**Western Star  
Service Bulletin**

## General Information

A new improved fuel-level sending unit, manufactured by KUS, is available for retrofitting the fuel-level sending unit on all Western Star vehicles. No parameter changes are required. A new connector is required for the retrofit. See **Fig. 1**.

**Fig. 3, Installing the Gasket**

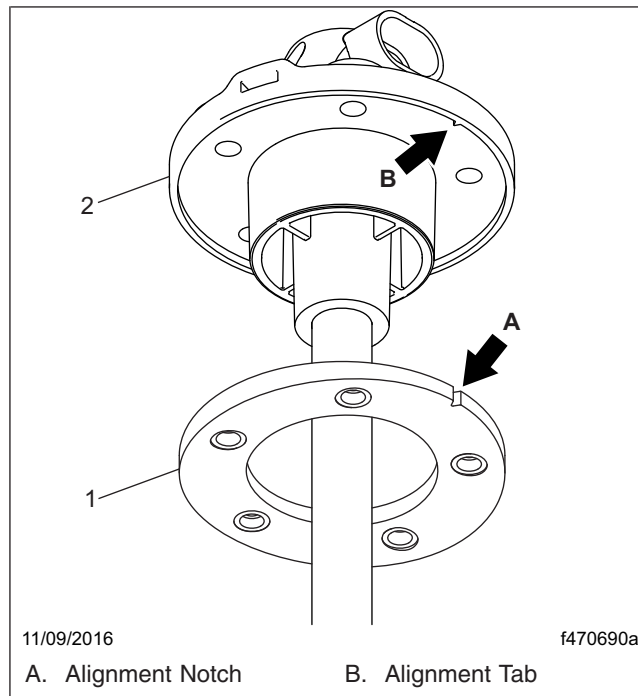
3. Disconnect the fuel-level sending unit harness connector.
4. Remove the five fasteners from the flange of the fuel-level sending unit and discard them.
5. Remove and discard the P-clamp from the chassis harness.
6. Lift the fuel-level sending unit out of the hole in the tank.
7. Install the gasket on the new KUS fuel-level sending unit, making sure the "UP" side of the gasket is against the unit head, and the alignment notch on the sender aligns with notch on the gasket. See [Fig. 3](#).

**Fig. 5, Tightening Sequence**

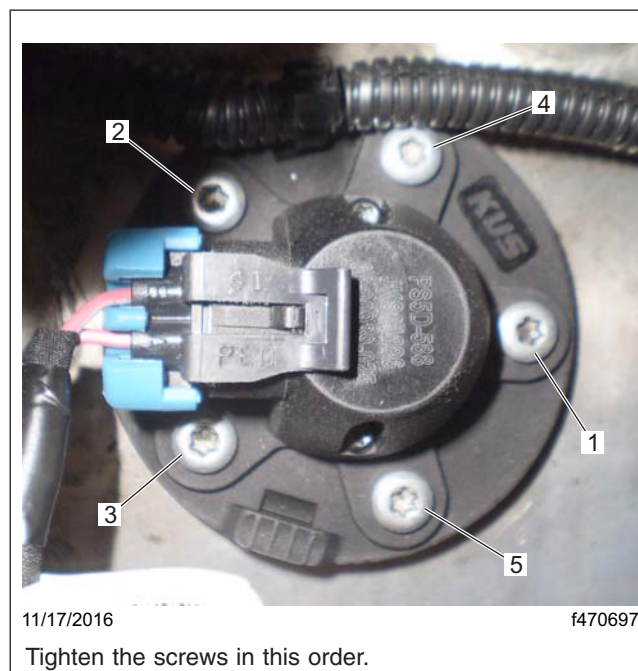
10. Using the tightening sequence shown in [Fig. 5](#), and even progression to distribute the torque evenly around the fuel-level sending unit, sequentially tighten the screws 15 to 25 lbf-in (160 to 212 N-cm).
11. Cut the old connector from the fuel-level sending unit harness, and splice the new pigtail to the chassis harness and the sender receptacle. See [Fig. 6](#).

**Fig. 7, Harness Connected and Secured**

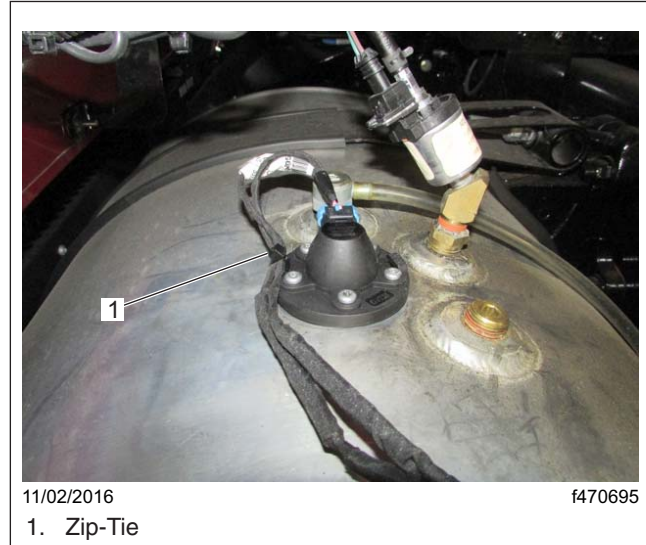
12. Connect the harness to the fuel-level sending unit.
13. Secure the harnesses to the sender with a zip-tie. See [Fig. 7](#). Do not use a P-Calmp.
